BURITI EPCMV PROJECT

**DRUG PRODUCT
FIRE ALARM RISER DIAGRAM**

7A-I-0-7-02

1 Fire Alarm Riser Diagram

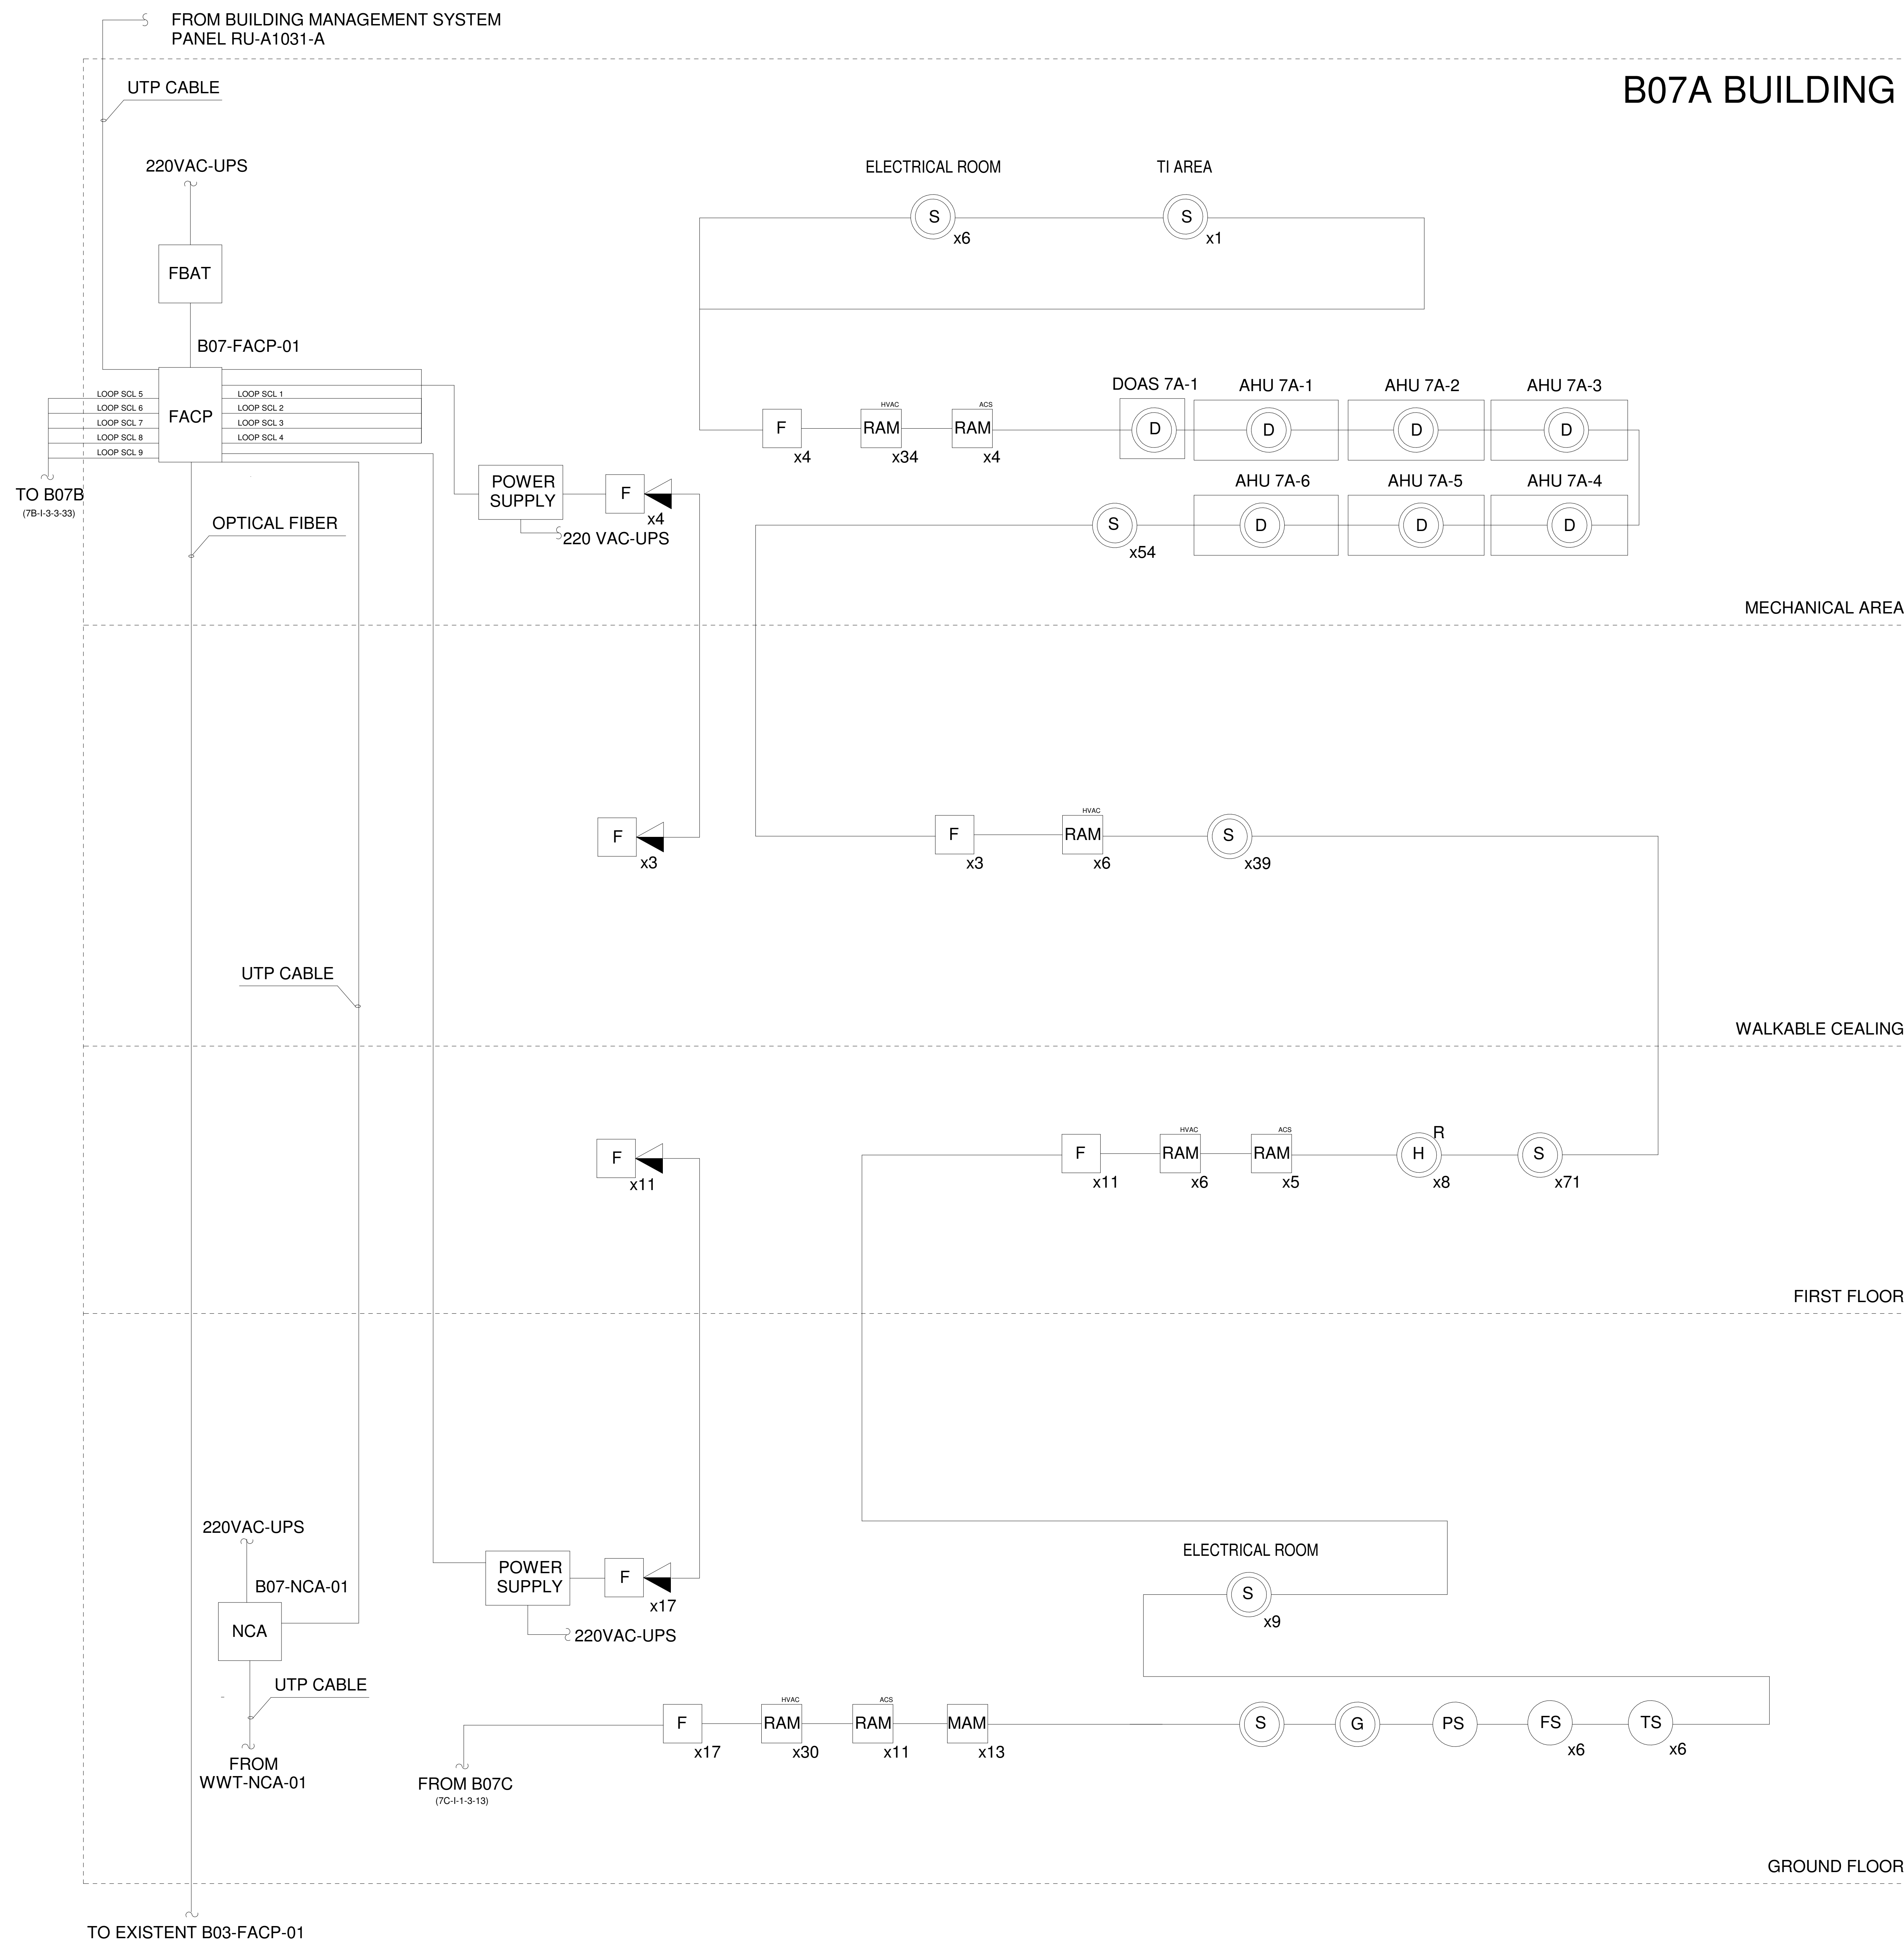
- CANCELLED PRE-ACTION SYSTEM IN ELECTRICAL ROOMS.
- CANCELLED NOVEC SYSTEM IN AUTOMATION ROOM.
- CANCELLED SMOKE DETECTOR IN DUCT FOR AHU EXHAUST.
- UPDATED QUANTITY OF THE FIRE ALARM COMPONENTS.
- ADDED THERMO DETECTOR IN AUTOCLAVE ROOM.

- ADDED B07-NCA-01.
- RELOCATED B07-FACP-01.
